Rezoning Application: MM 25-1415
Zoning Hearing Master Date: April 27, 2026
BOCC Land Use Meeting Date: June 9, 2026

1.0 APPLICATION SUMMARY

AGENCY REVIEW COMMENT SHEET

2.5 Proposed Site Plan (partial provided below for size and orientation purposes. See Section 8.0 for full site plan)

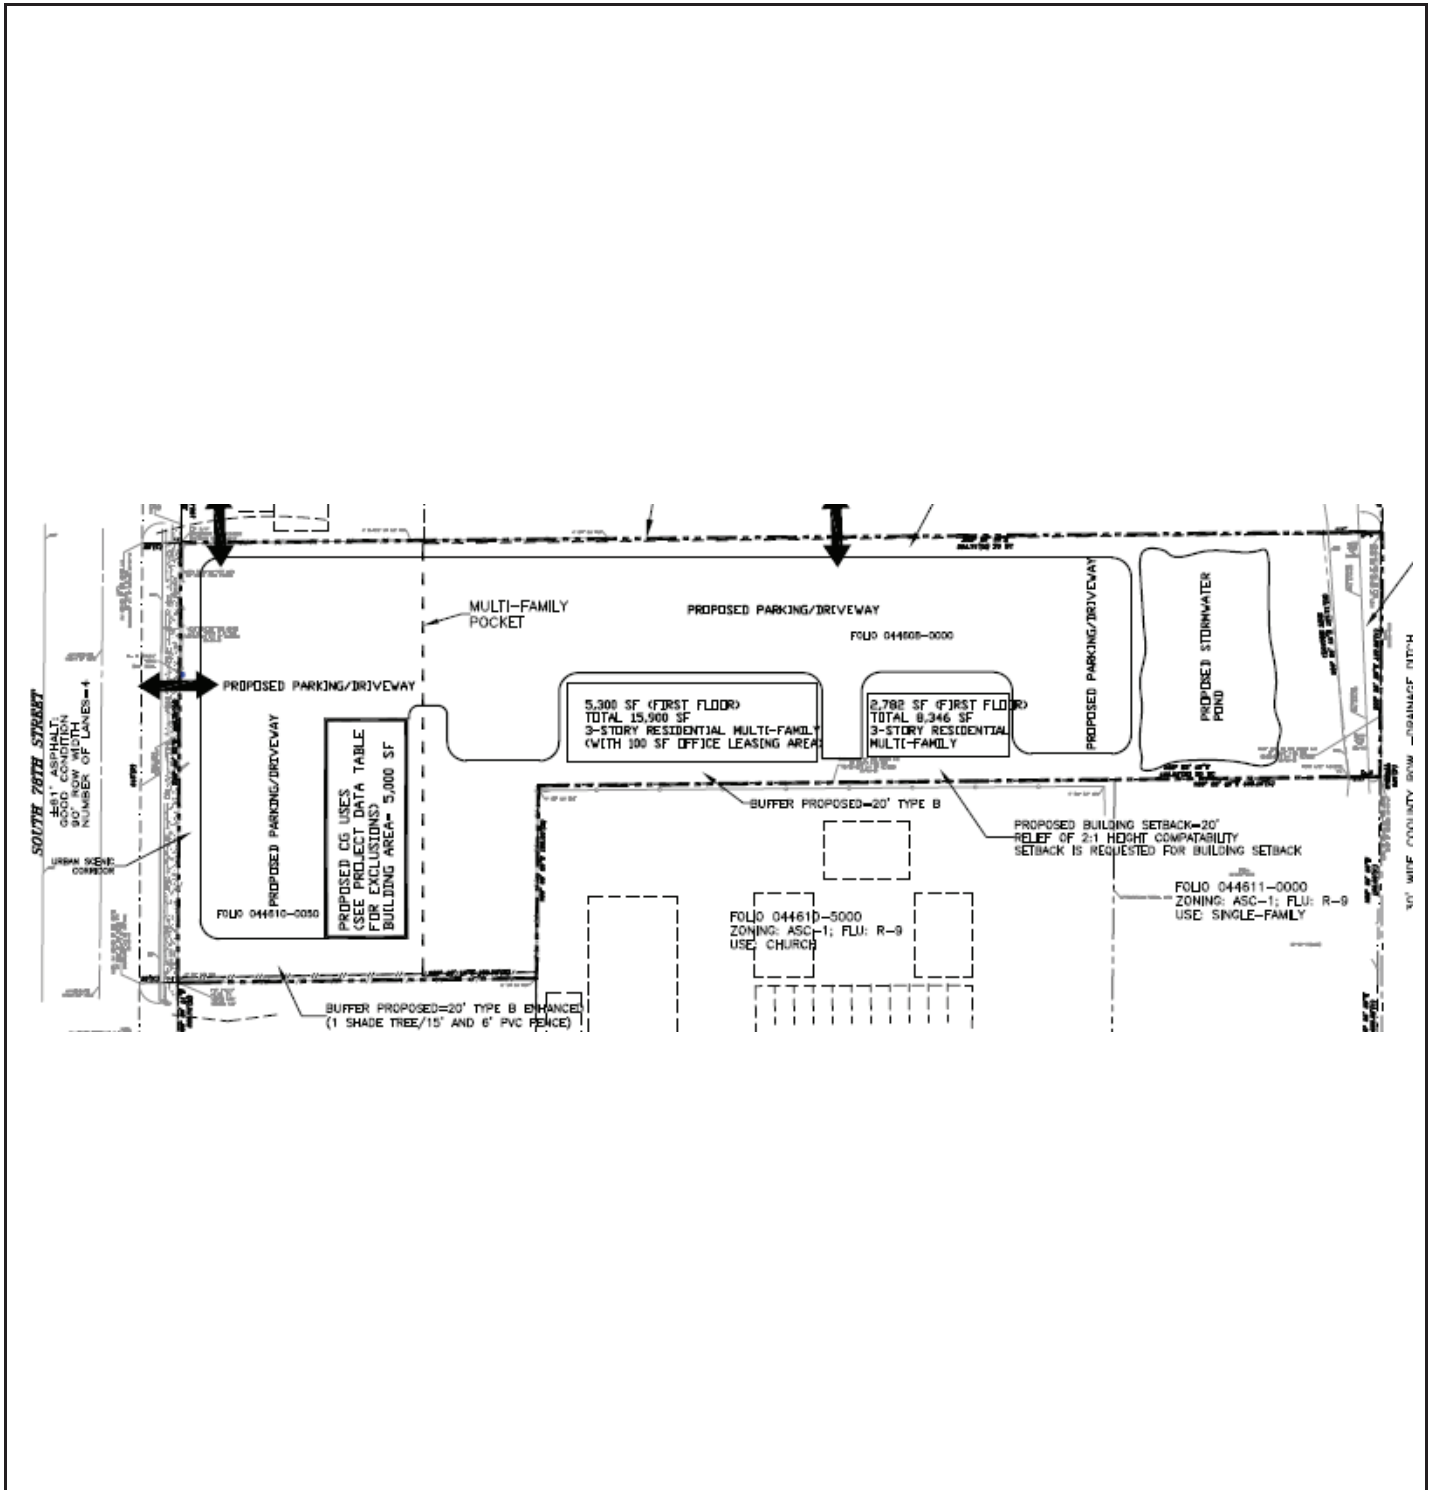
- (1) (1) to reduce the 20-foot wide with Type "B" buffer required along the northern property boundary **to a 5-foot buffer with Type "A" screening**. The applicant's justification in part included that the BPO located to the north is a less active parking area and a vacant / forested area. Additionally, the area to the northwest adjacent to the Commercial Pocket would not require a buffer.

- (2) **Not provide an internal 20' wide buffer with Type "B" screening between the Commercial Pocket and the Multifamily Pocket**. The Applicants' justification states in part that there is approximately 60' between the proposed uses within the respective pockets. Additionally, the applicant states that the property owner is the same for the unified development and the buffer does not serve the same purpose internally. The applicant proposes to maintain and enhance the buffer adjacent to the immediate south boundary of the Commercial Pocket.

To further mitigate potential impacts, the applicant proposes a condition requiring an enhanced 20-foot buffer with Type "B" screening along the southern property boundary adjacent to folio 44610.0000, which is developed with a single-family home. Type "B" screening requires a row of evergreen shade trees which are not less than ten feet high at the time of planting, a minimum of two-inch caliper, and are spaced not more than 20 feet apart. The applicant proposes to

1. Revise Site Data Table to delete "Building Setback for Commercial" to "PD Building Setbacks".
2. Revise Site Data Table to revised "Rear (East) = 6 feet" to "Rear (East)= 50 feet"
3. Remove the two arrows along the project's northern project boundary labeled as "Proposed Vehicular and Pedestrian Cross-Access".
4. Add a bounding box along the project's northern project boundary which abuts the adjacent parcel to the north and include a label which states "Proposed Vehicular and Pedestrian Cross-Access – See Conditions of Approval".

Prior to certification, the applicant will be required to amend the PD site plan to:

- Remove the two arrows along the project's northern project boundary labeled as "Proposed Vehicular and Pedestrian Cross-Access".
- Add a bounding box along the project's northern project boundary which abuts the adjacent parcel to the north and include a label which states "Proposed Vehicular and Pedestrian Cross-Access – See Conditions of Approval".

Driveway Spacing Exhibit

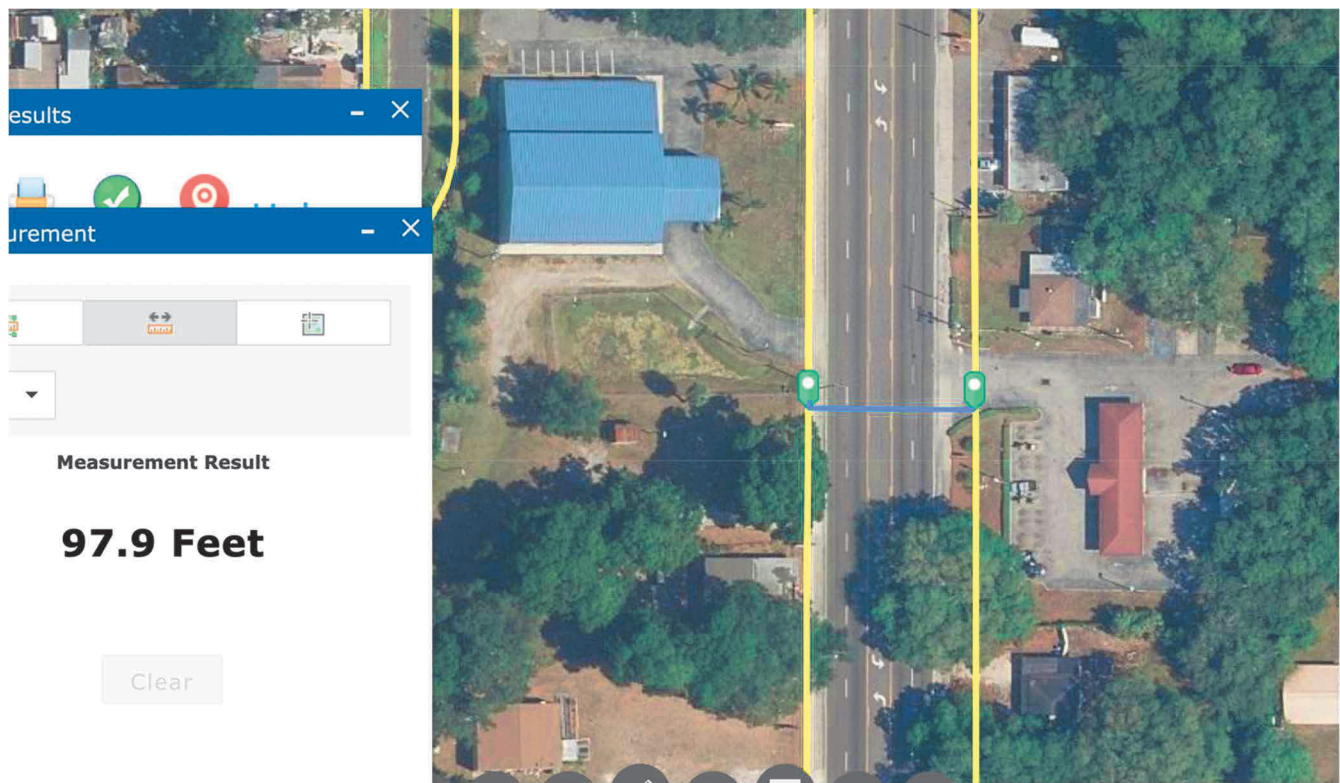
The subject property is in for rezoning, as is shown on the attached **Site Plan** and **Location Map**. This variance is to request that the developer not be required to meet LDC driveway spacing.

- c. Without the variance, reasonable access cannot be provided. *It is not reasonable to deny the site access to 78th Street when the development is mixed use, allowing for internal travel on-site between retail and residential land use, as well as vehicular and pedestrian cross access to the north. It also provides needed housing stock for this part of Hillsborough County.*

REVISION DATE	10/2023	TRANSPORTATION DESIGN MANUAL		SUBURBAN 4 LANE DIVIDED TYPICAL SECTION	DRAWING NO. C3-4D	SHEET NO. 6 OF 15
---------------	---------	---------------------------------	---	---	----------------------	----------------------

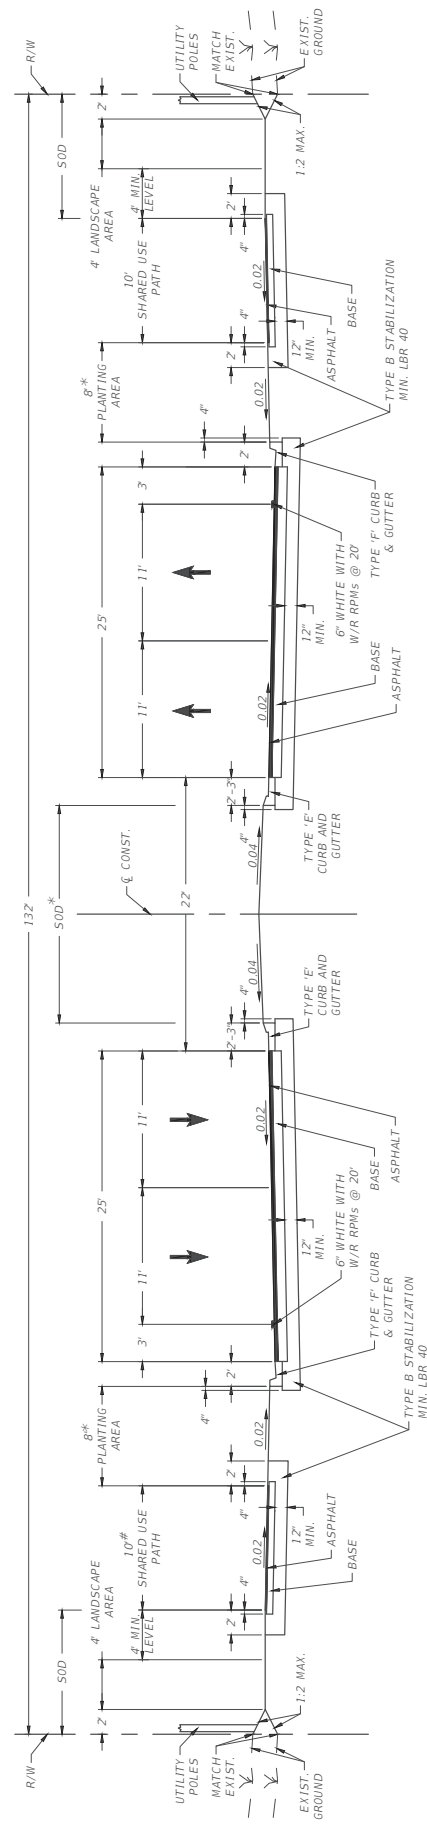
The subject property is in for review as MM25-1415 to allow for the development of a mixed use project, as is shown on the attached **Site Plan** and **Location Map**. This variance is to request that the developer not be required to bring 78th Street up to the above-described standards.

- a. There is unreasonable burden on the applicant. *78th Street cannot be constructed fully to standard because of the available right-of-way width. The existing right-of-way width is 98 feet. The C3-4D typical section calls for 132 feet of right-of-way, which allows for an 8 foot planted area between the back of curb and the sidewalk (as opposed to the 2 feet of asphalt present on 78th Street). The C3-4D typical section also calls for multi-use paths, rather than the 5 foot sidewalks present on 78th Street. Notwithstanding these deficiencies, the roadway has been constructed as closely as possible to the typical section given the available right-of-way. Importantly, 12 foot travel lanes have been constructed, and only 11 foot travel lanes are required per the typical section. For these reasons, it would be unreasonable to deny the developer the ability to develop the property based upon the conditions of this roadway.*
